**Re: NWB File No. 2AM MEA1526- In-Pit Disposal: Flooding Strategy.**

<b>Interested Party:</b>	<b>Natural Resources Canada</b>	<b>Rec No.:</b>	<b>NRCAN-05</b>
<b>Re:</b>	<b>Water level controls during in-pit deposition periods</b>

**Figure 5.1: Closure sequence flowchart**

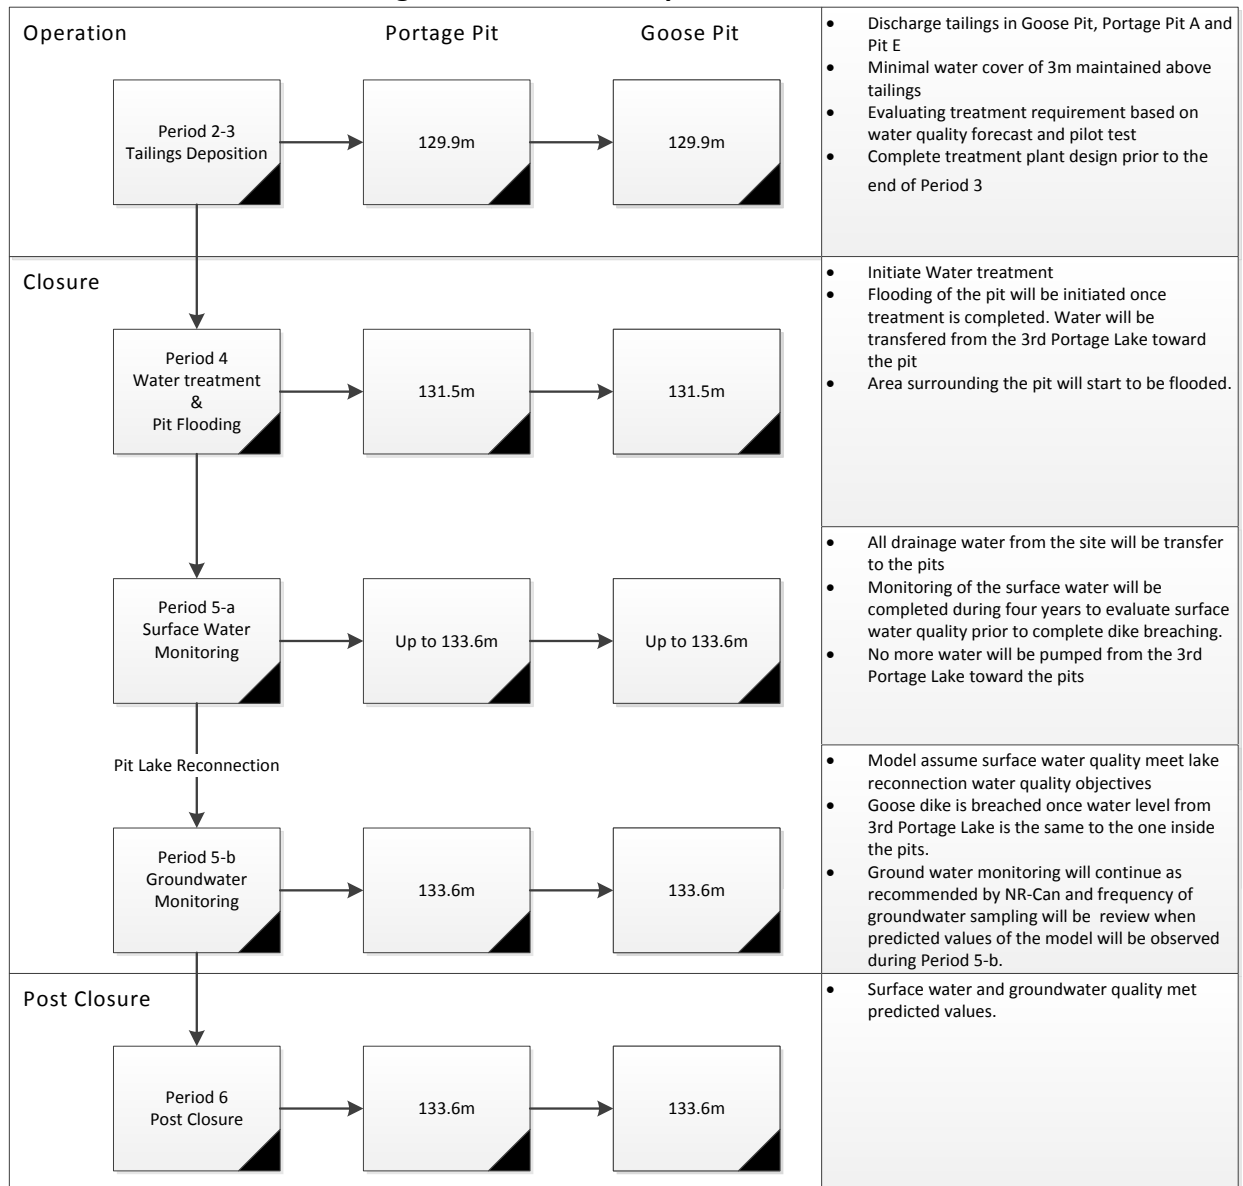
*NRCAN recommends that the proponent should clearly state the anticipated pit water levels during Periods 4 and 5 and resolve the apparent contradictions between pit water levels and flooding of the areas surrounding the pits. The proponent should state when the area surrounding the pits will be flooded and whether this will result from natural drainage or pumping, or breaching of the dikes.*

*NRCAN recommends that “post-closure” groundwater contaminant simulations towards Second Portage Lake should begin when pit water levels exceed those of the Second Portage Lake.*

Agnico Eagle agrees to provide further information to address the NRCAN recommendation and has developed the flowchart presented on the Figure 5.1 to summarize the closure sequence (Period 4 and 5) with the water elevation at the end of each phases within the pits. Water elevations presented in this flowchart are different than the tailings beach elevation which will reach maximum elevation 125m. Also, Agnico Eagle would like to clarify that the average pit crest elevation is 130m. The closure monitoring period (Period 5) will now have two segments to comply with Information Request NRCAN-10 made in July 2018.

Agnico Eagle agrees with NRCAN recommendation that “post-closure” groundwater contaminant migration towards Second Portage Lake should begin when pit water levels exceed those of the Second Portage Lake and will integrate this recommendation in the Version 3 hydrogeological model (sensitivity analysis of Version 2 (SNC, 2018a)). For clarification, the assumption made in the Versions 1 (SNC, 2017) and 2 hydrogeological models was that “post-closure” groundwater contaminant migration towards Second Portage Lake starts once water level within the pits reach 3<sup>rd</sup> Portage Lake elevation (end of Period 5a).
